# Indoor Station Firmware V2.2.92\_build241008

## Release Note (2024-10-25)

Device Model	DS-KH8350-WTE1, DS-KH8350-TE1, DS-KH6320-WTE1, DS-KH6320-TE1, DS-KH6320Y-WTE2, DS-KH6320EY-WTE2, DS-KH8520-WTE1, DS-KH6320-WTDE1, DS-KH6320-TDE1
Firmware Version	V2.2.92_build241008

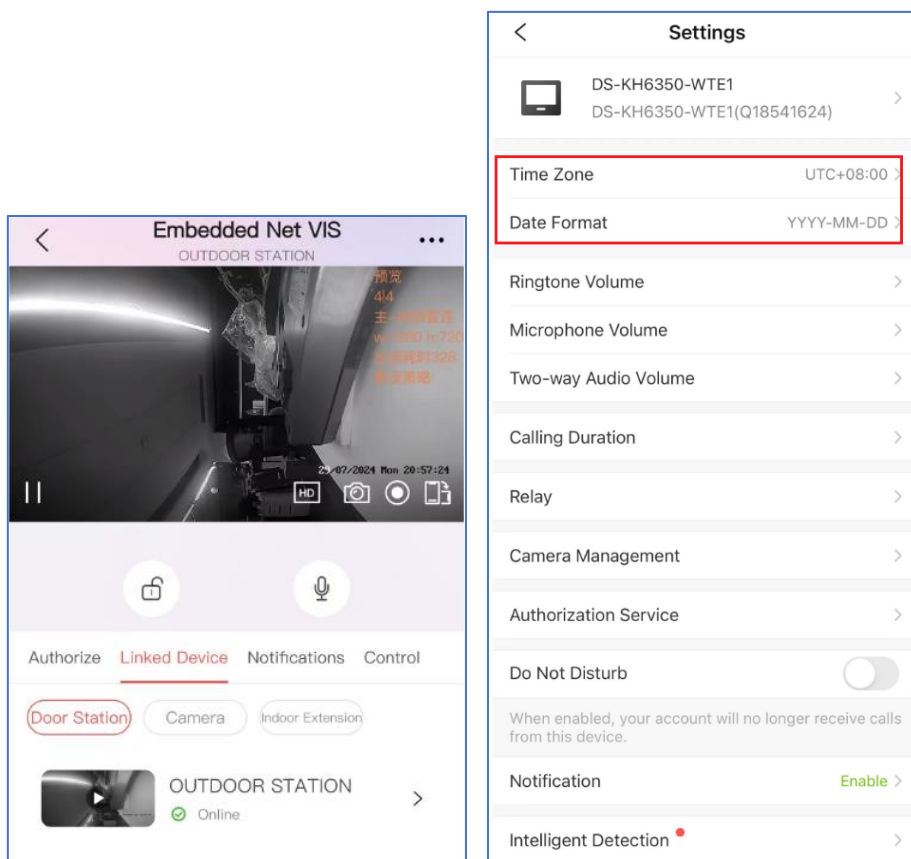
1. Optimize the audio quality with NetEQ algorithm and add 16KHz sampling rate (only support 8KHz before), supports more audio formats (auto-negotiation), including G.711u, G.711a, G.722.1
2. Support switching between main and sub stream (HD and Basic) when live view the door station from hik-connect app

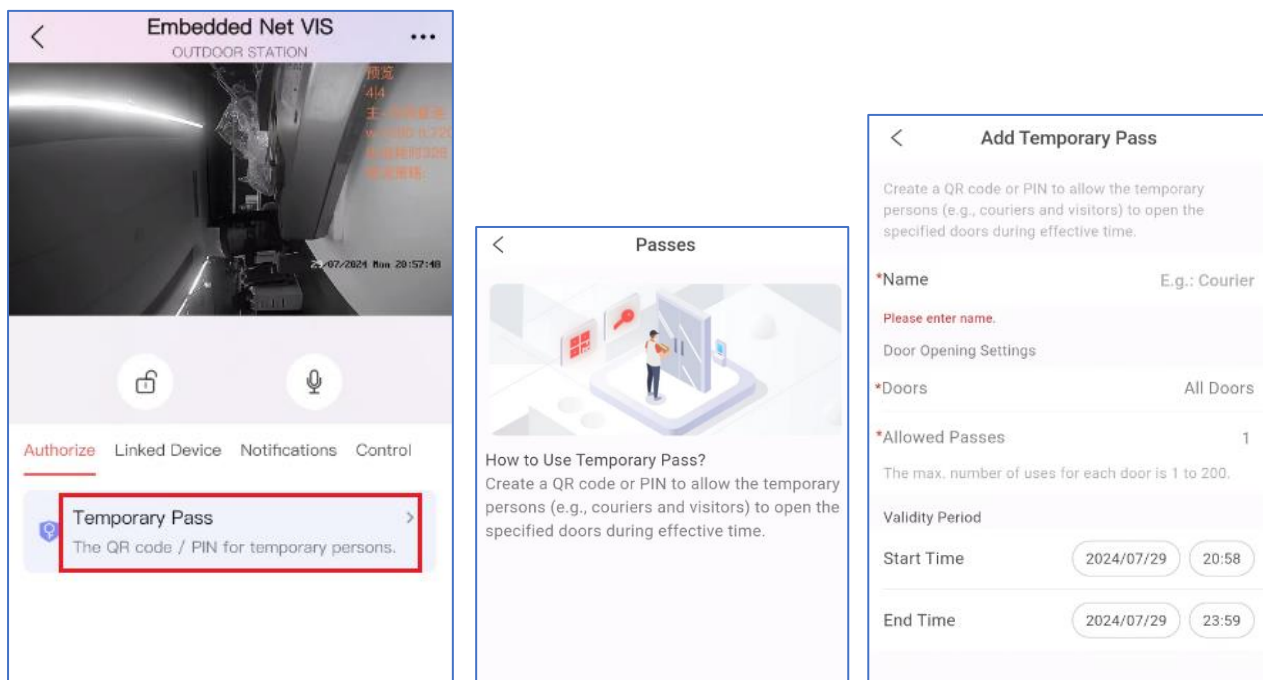
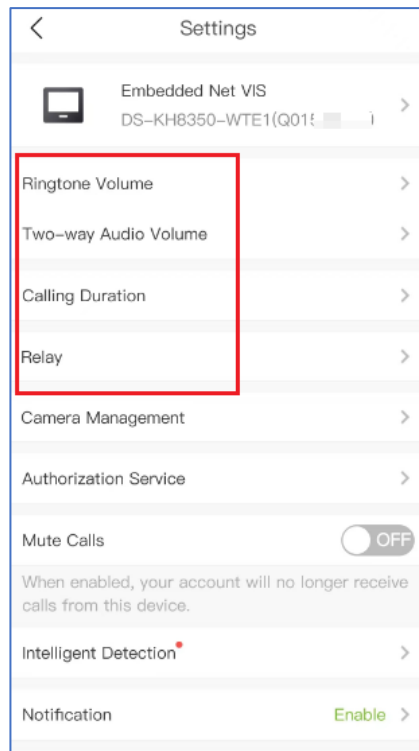
5. Support adding temporary visitor QR and PIN on Hik-Connect and apply to the door station.

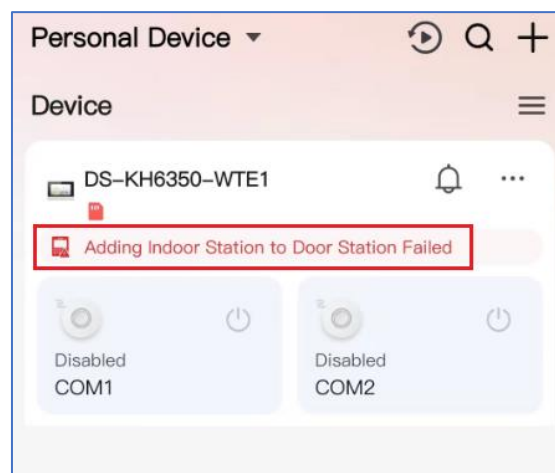
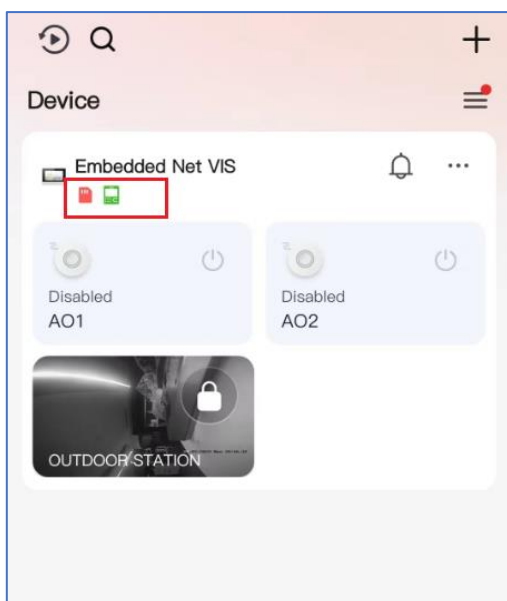
6. Configure the ringtone/intercom audio volume, call duration and TF card parameters from Hik-Connect

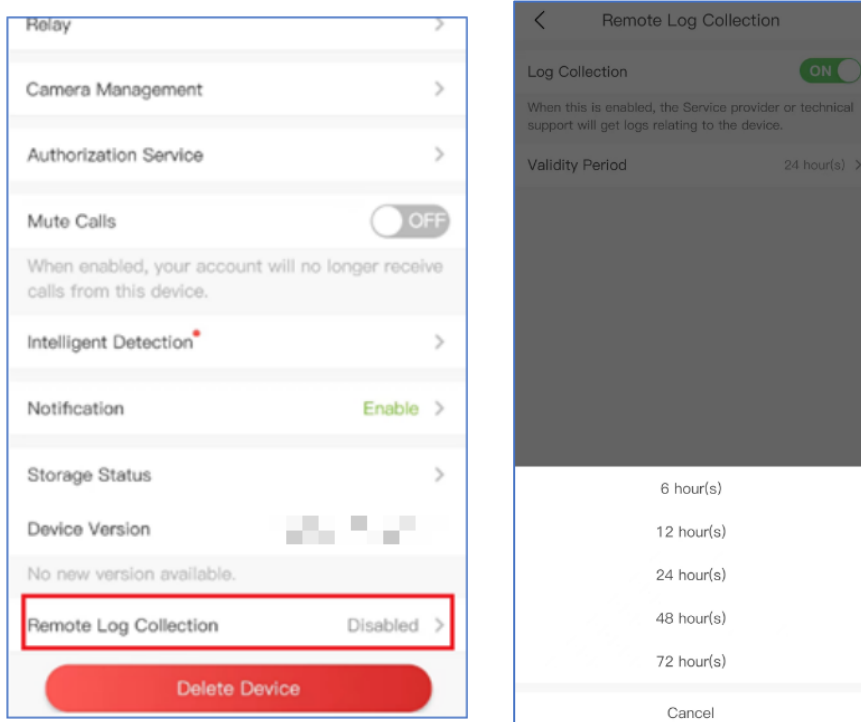
8. Support collecting the device log from Hik-Connect cloud after the end user enable the

authorization service from App, within the valid duration, technical support can collect the device log.

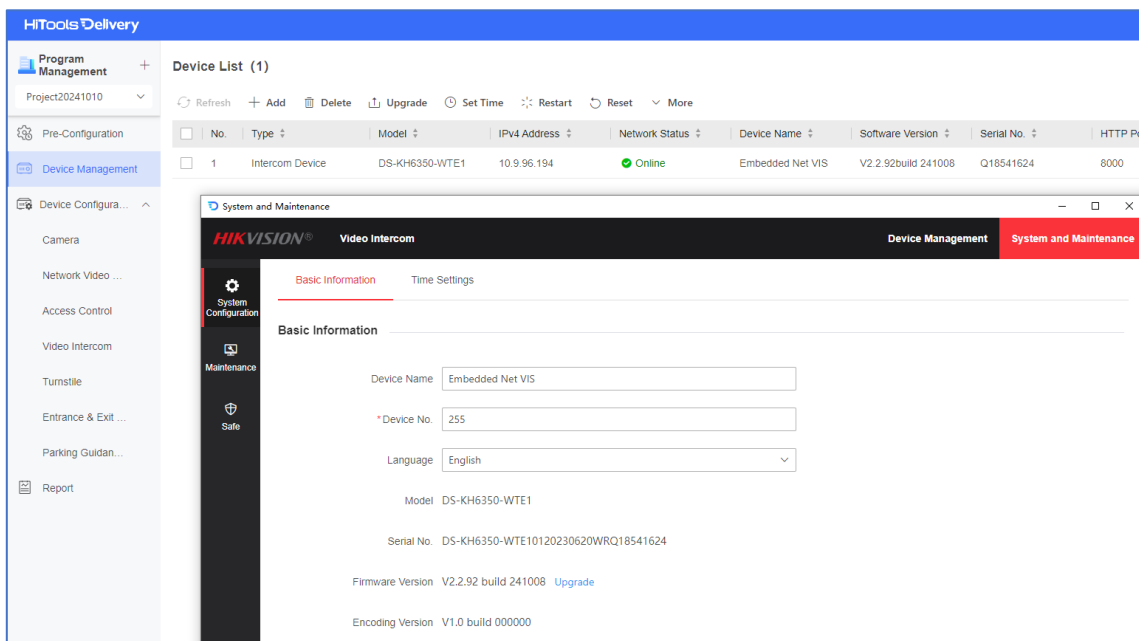
9. Compatible with HiTools Delivery, and open remote configuration menu to make some settings.

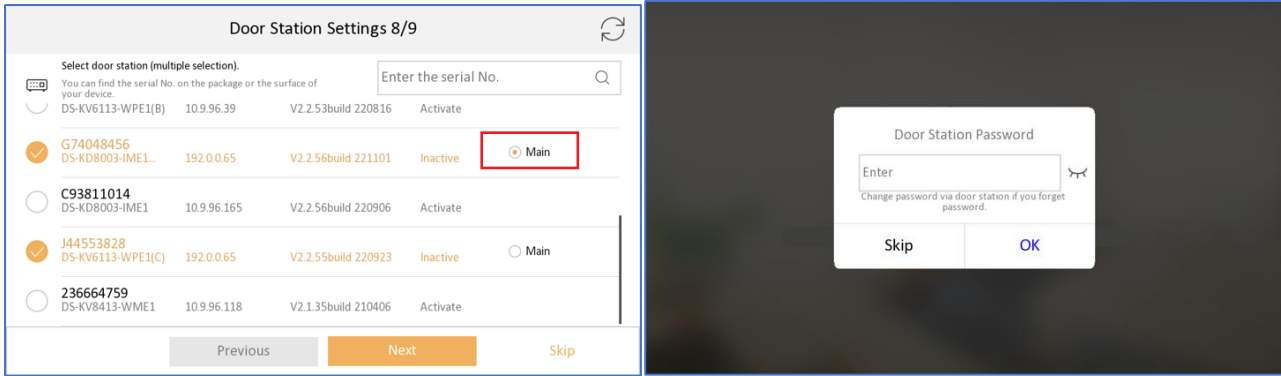
B. Link indoor station with main and sub door station

- a. *the first selected will be the main door station by default, the second will be sub1, 3<sup>rd</sup> will be sub2, etc. You can also cancel and select the main door station manually.*
- b. *Maximum select 17 door stations at one time (1 main and 16 sub door stations)*
- c. *If the selected devices are not activated, indoor station will activate them with same activation and registration password, then set the IP address for them in same network segment automatically.*
- d. *If the door station is already activated with different password, it will prompt you to input door station password*
- e. *If the main and sub door station are activated with different activation password, the registration will be failed (sub door station can't call indoor station).*

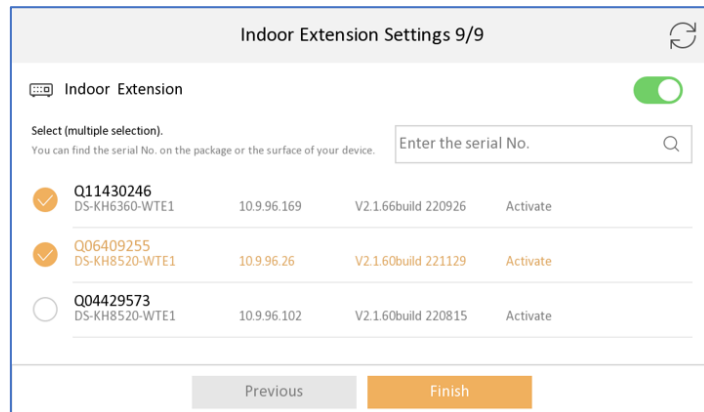
### C. Link indoor station with indoor extension

- The selected indoor station will be and numbered as indoor extension 1,2,3...
- Maximum select 5 indoor extensions at one time
- If the selected devices are not activated, indoor station will activate them with same activation and registration password, then set the IP address for them in same network segment automatically.
- If the selected devices are activated with different password, the registration will be failed (door station can't call indoor extension).

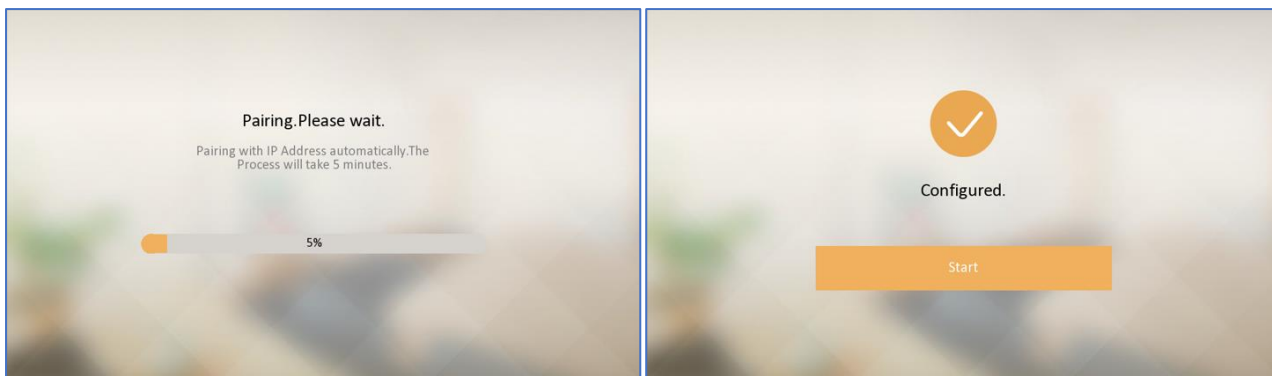
### D. Pairing with main door station, sub door station and indoor extension

**Note:** The pairing time duration depends on the device quantity you selected in previous steps, it will take about up to 5 mins, please wait patiently until the process finish and show "Configured" as below.

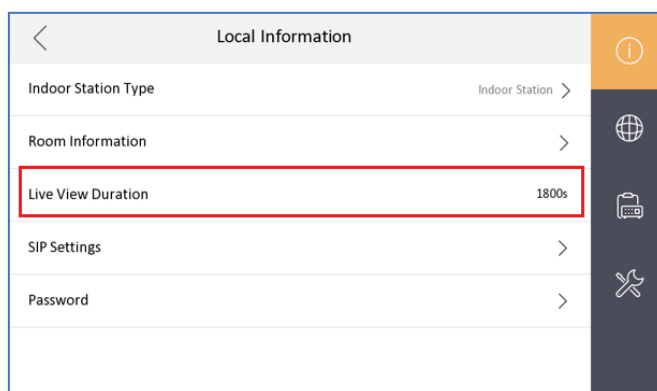
1. Optimized the icon of door station registration status in the main UI up right corner.

*Note:* If the door station call indoor station failed, you can click this icon  to register to door station manually, if register failed, it will indicate the reason for the failure.

Before	Now
Indoor station registers to door station success		
Indoor station registers to door station failed		
Indoor station registers to door station and KM9503 success

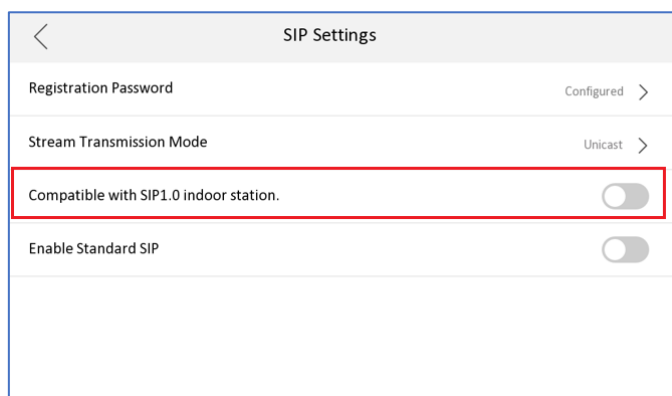
- Support switching between protocol 1.0 and 2.0, by default it's protocol 2.0. After enable, the indoor station is compatible with protocol 1.0 indoor extension and not compatible with protocol 2.0 indoor extension.

*Note: After enable, all indoor extension of this indoor station must be protocol 1.0 firmware, don't mix protocol 1.0 and 2.0 indoor extension under same indoor station, or it will result to calling failed.*

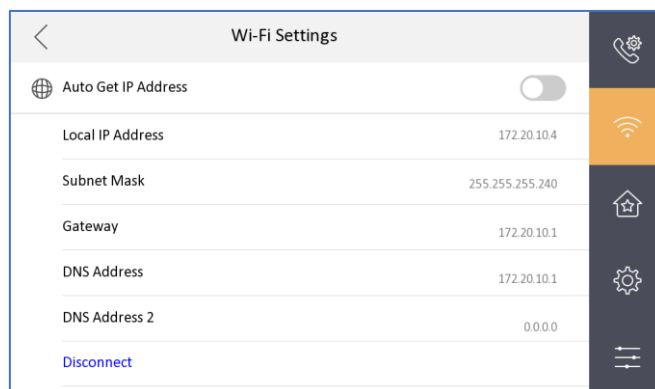
1. Supports static IP address configuration of Wi-Fi (DHCP, IP address, subnet mask, gateway, DNS1, DNS2).

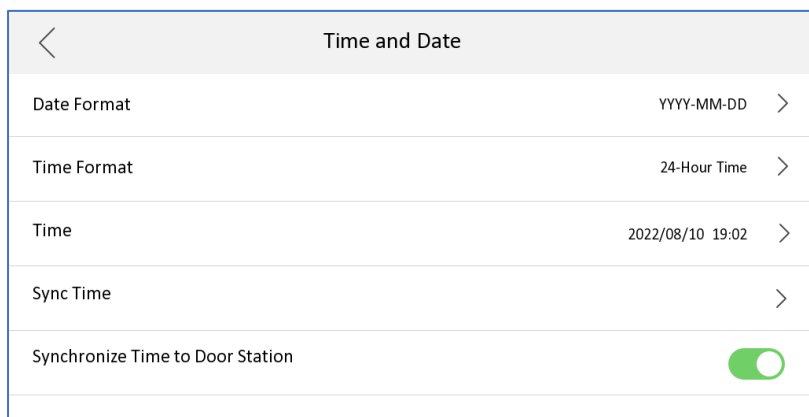
2. Supports configuring time and time zone for the door station.

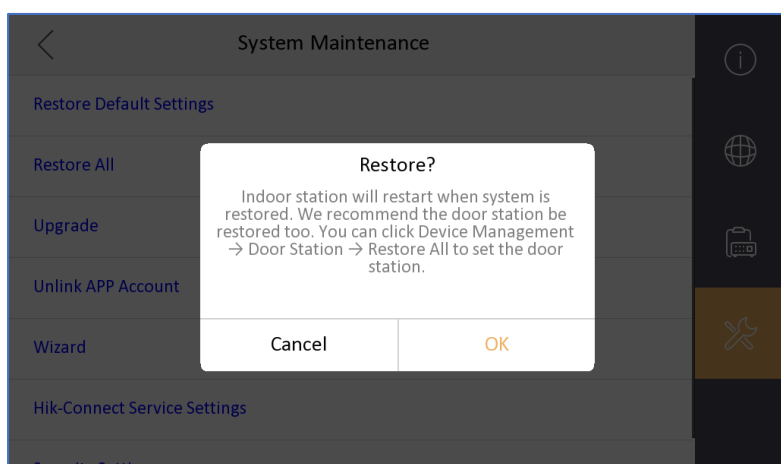
- 1. Optimizes the maintenance interface with a pop-up window when clicking **Restore** or **Restore All**.

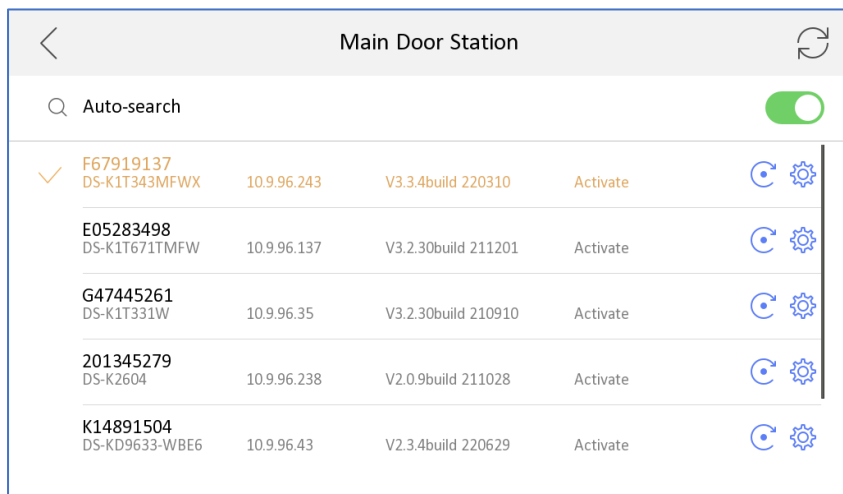
- 2. Adds the effect of selected door station when relating devices in wizard.

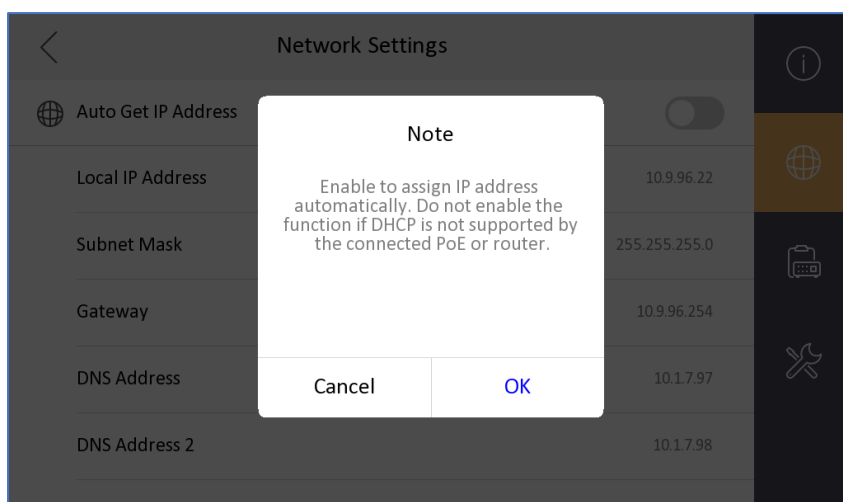
3. Adds a prompt when assigning network IP address automatically.

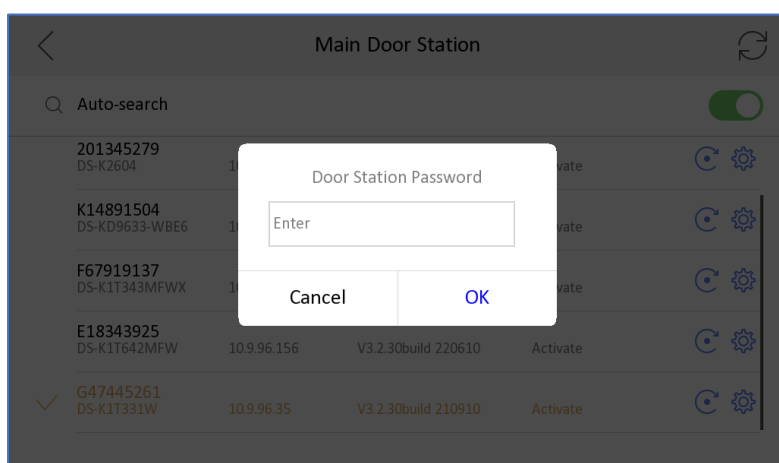
4. In configure wizard to related door station, when the door station password is different from the indoor station, prompt information will pop.

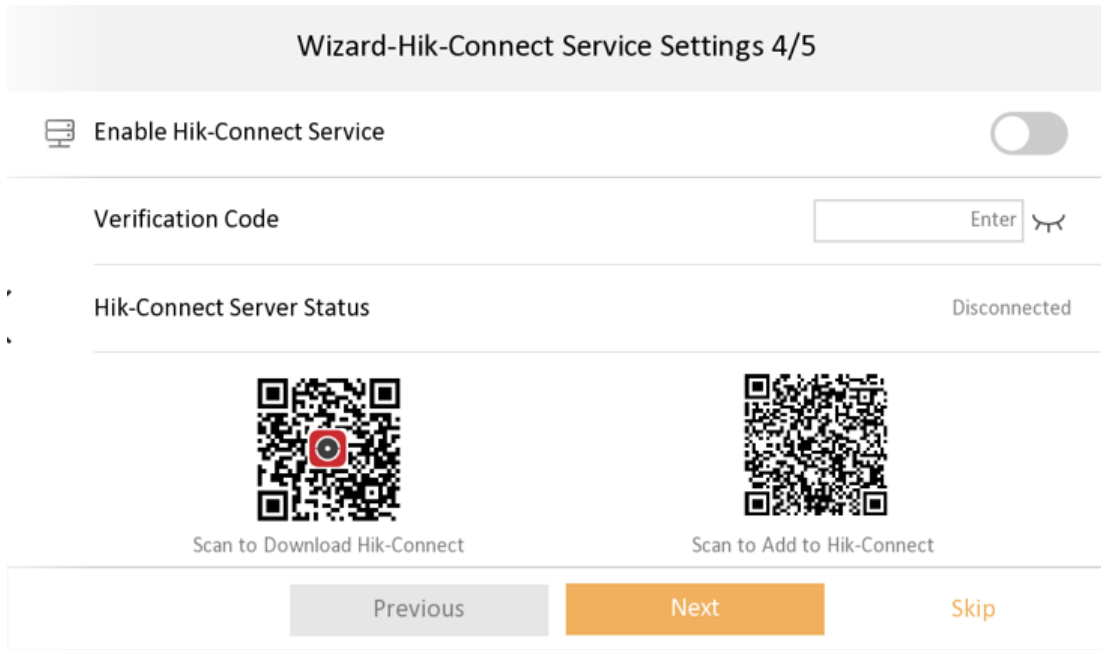
1. Optimize registration password settings in Wizard.

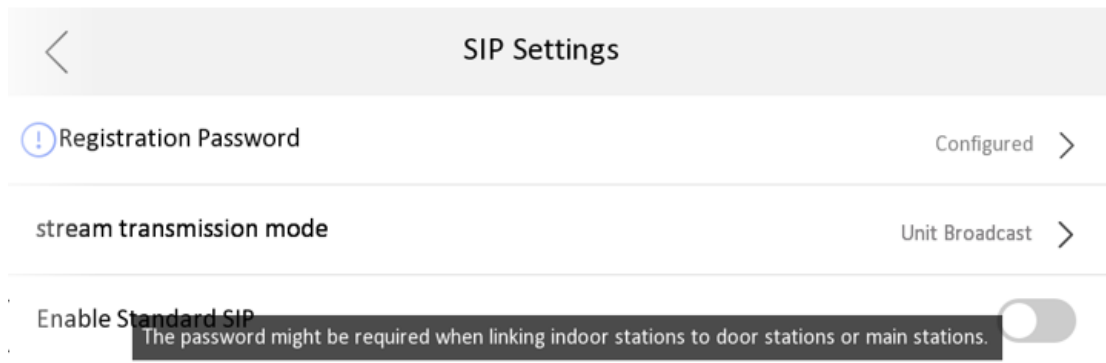
2. Optimize Hik-Connect password configuration page.

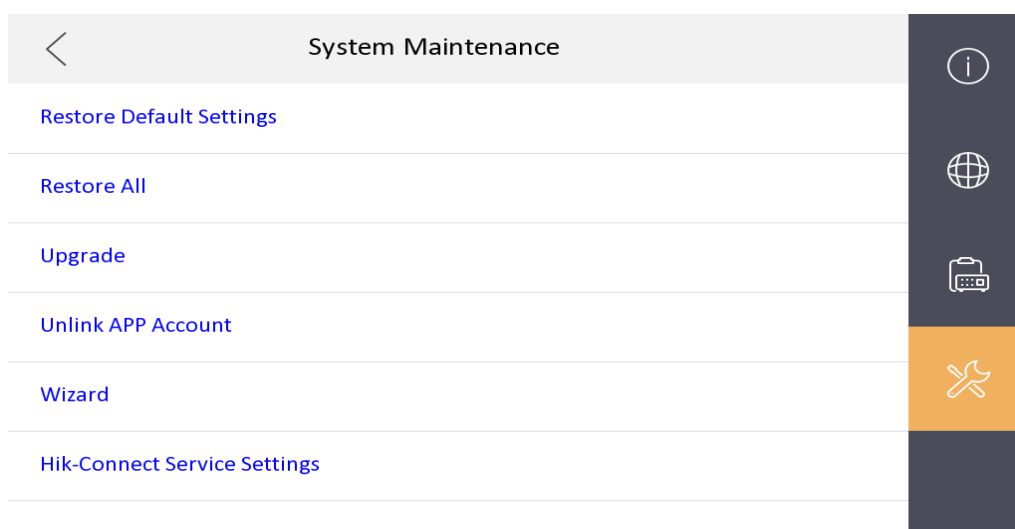
1. Verification code is empty by default.

- Hik-Connect Service Settings is changed to the place of Settings→ Advanced Settings→ Configuration→ System Maintenance.

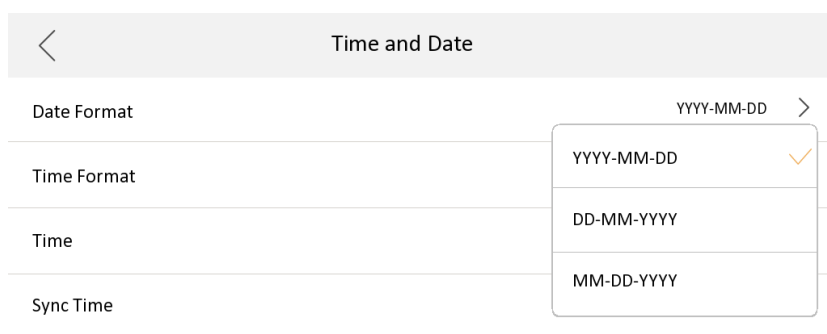
1) Support three formats in Settings->General Settings->Time and Date interface, set year-month-day, day-month-year, month- day - year

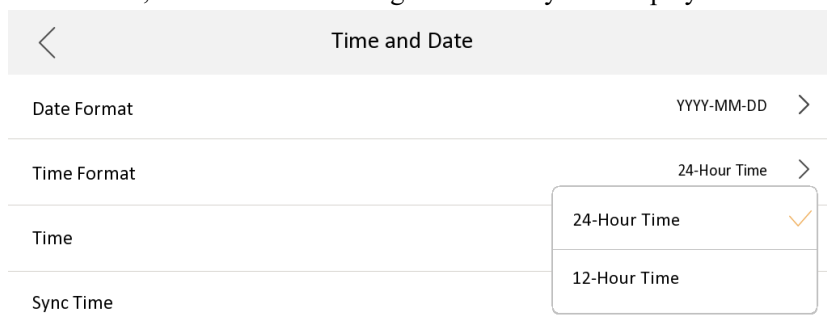
2) Support the Settings->General Settings->Time and Date interface, set the 12-hour system, 24-hour system two formats, and the default setting is 24-hour system display.
